**Town of Belgrade
Planning Board
May 20, 2021 / 6 p.m.**

*****Discussion and Policy Determination for the Definition of 'height of a structure'.*****

Feder/Elliot Thayer (Thayer Engineering). Location: 163 Burton Woods Rd (Great Pond), Map 37 Lot 24. Purpose: nonconforming lot and nonconforming structure (demolish and replace existing residence).

To: Belgrade Planning Board
Fr: Rich Baker
Da: May 1, 2021
Re: Height of a Structure

Where Measure Maximum "Height of a Structure"?

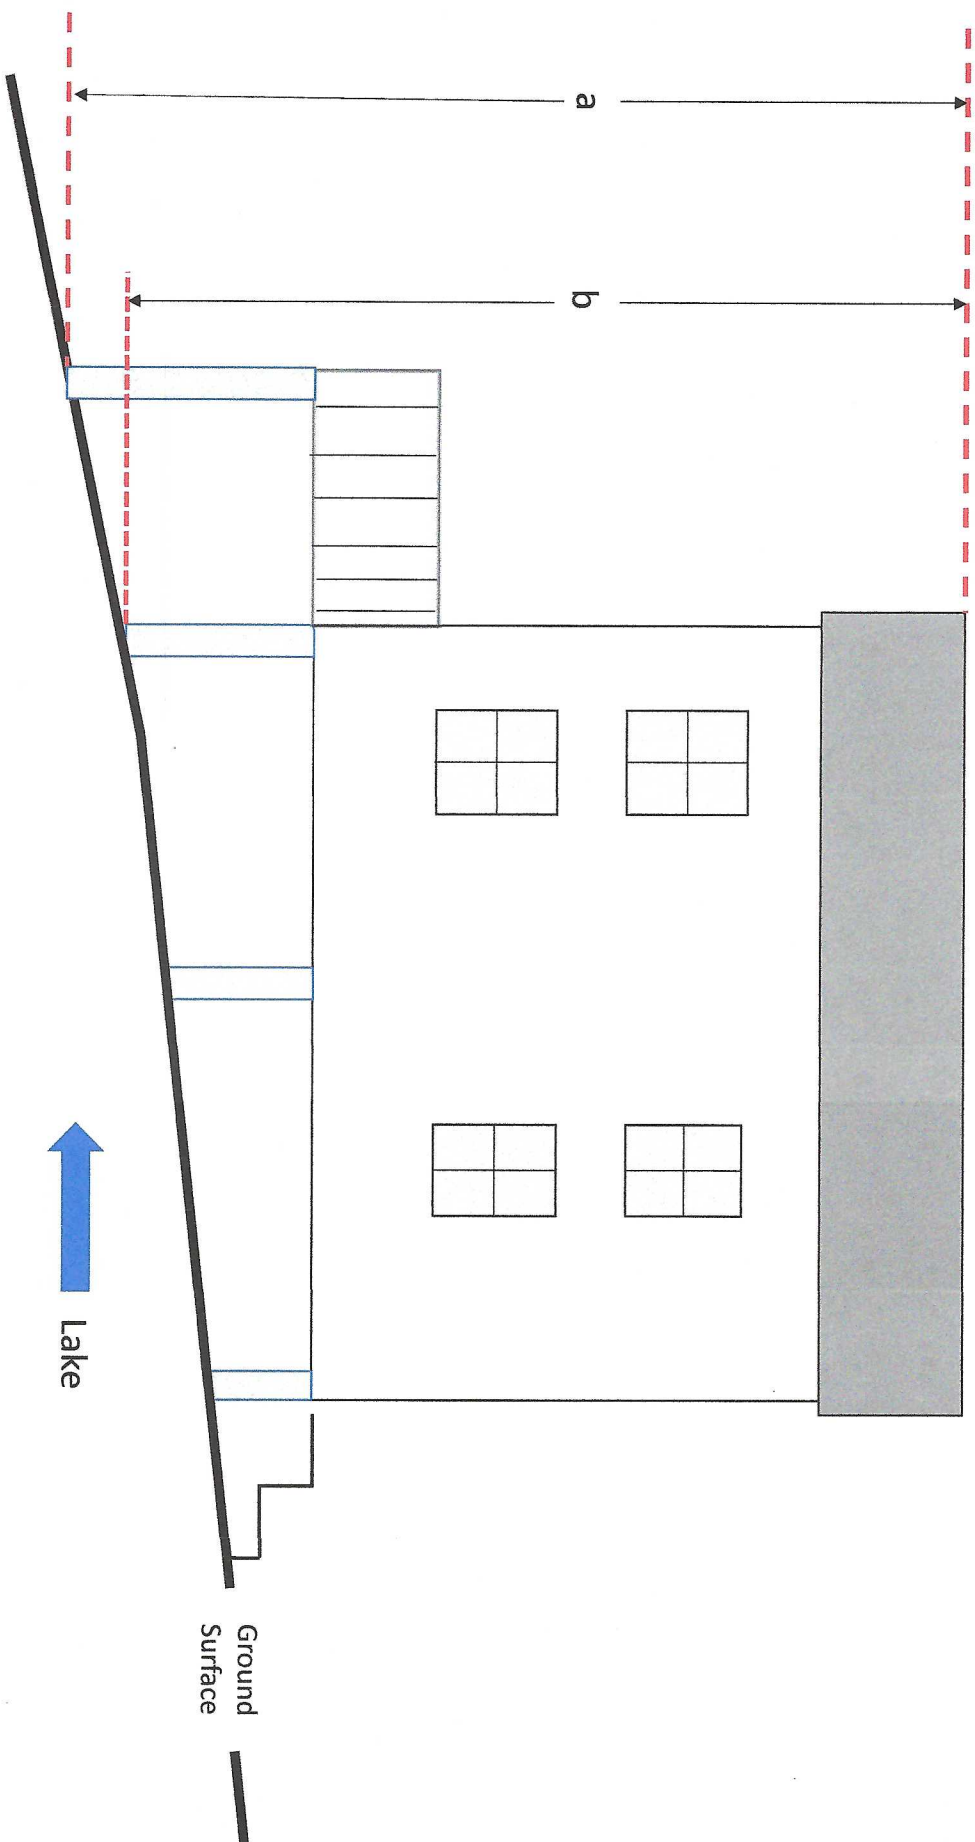
At the April 20, 2021 special planning board meeting conducted by me, George Seel, and Sara Languet, we began processing an application which generated a question pertaining to the proposed structure's height. Section 15.B(2) of the shoreland zoning ordinance limits structure height to 25 feet. The proposed structure will be located on a slope, and will have an attached elevated deck. I have included a generic sketch of the situation that we are dealing with. The question that must be answered is whether structure height is measured from the ground level at the front of the deck or the front of the new camp. George, Sara and I feel that this decision should be made by the full board.

The applicant's consultant argues that the height of the structure is to be measured from the front edge of the camp foundation at ground level ("b" on the attached schematic), not the front of the deck at ground level ("a" on the attached schematic). When we suggested that the structure's height is to be measured from the deck at ground level, he sought the opinion of Colin Clark, Maine DEP's Shoreland Zoning Coordinator. Colin provided a response that supported the applicant's interpretation. Essentially, Mr. Clarke stated that the DEP has always maintained that structure height is measured from the main structure's foundation, since it was the portion that was first constructed. That position is not supported by the DEP's 2008 publication "*Maine Shoreland Zoning A Handbook for Shoreland Owners*". An illustration showing where building height is measured from, clearly shows that the height is measured from the base of the closest portion of the overall structure closest to the water (page 20 of the document). This is the same measurement location as "a" in the attached illustration.

I believe that the applicant's and Colin Clark's interpretation of "height of a structure" is not supported by the language in our ordinance. The correct interpretation can be attained from four definitions in the ordinance: "height of a structure", "structure", "accessory structure", and "principal structure". It has been the past practice of Belgrade's Planning Board that the maximum height of a structure be measured at the closest part of the structure to the lake, and it is DEP's interpretation which has changed in recent years for reasons that have not adequately been explained. For example, neither the Shoreland Zoning statute or the shoreline zoning guidelines has changed the definition of "height of a structure" to require this change in the location of where the maximum structure height is to be measured as now suggested by DEP.

I believe the above definitions support that the deck is part of the principal structure, and not an accessory structure, and that height is measured from the downhill side of the structure. There is no reference to what part of the structure was build first.

SITE PLAN

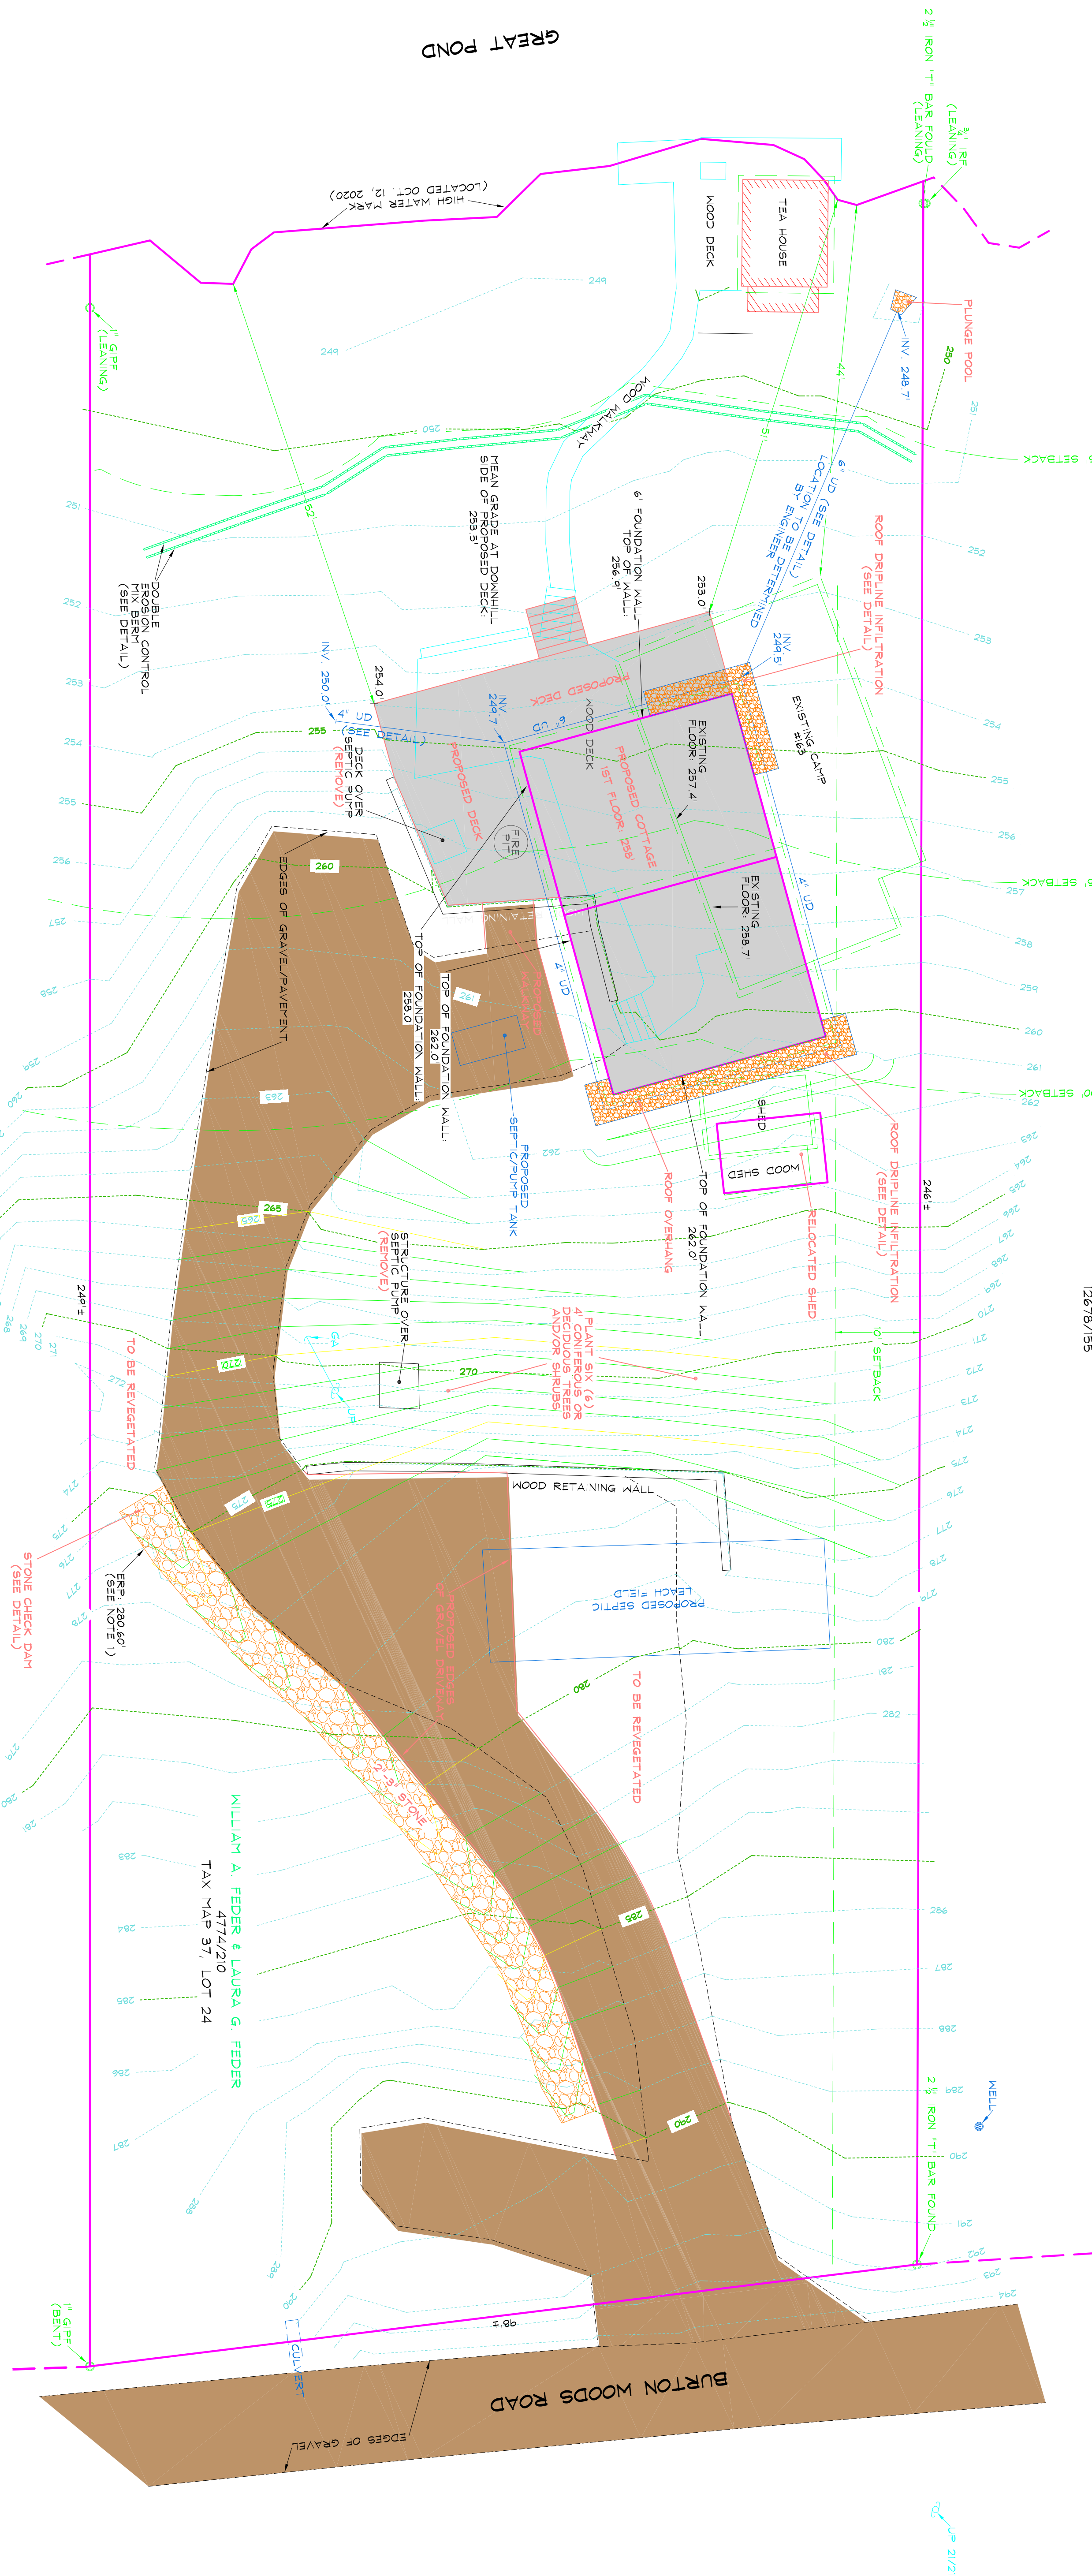
Gary, as just discussed by phone, attached is Bill and Laura Feder's site plan that incorporates the height limitations – see note 5.

The new cottage will meet the height limitations, and will be the same architectural design as submitted previously, with heights adjusted to conform.

Please use the previously submitted cottage plans for concept. I think note 5 should suffice to assure compliance.

REVISED 5/11/2021: NOTE 5

- 4) THE SITE CONTRACTOR SHALL BE A CERTIFIED CONTRACTOR UNDER MDER RULES.
- 5) THE MAXIMUM HEIGHT OF THE PROPOSED COTTAGE ABOVE THE MEAN GRADE OF 293.5' AT THE PROPOSED DRIPLINE SHALL NOT EXCEED 25 FEET FROM 75 FEET TO 100 FEET FROM HIGH WATER MARK, AND SHALL NOT EXCEED 25 FEET FROM 75 FEET TO 100 FEET FROM HIGH WATER MARK.
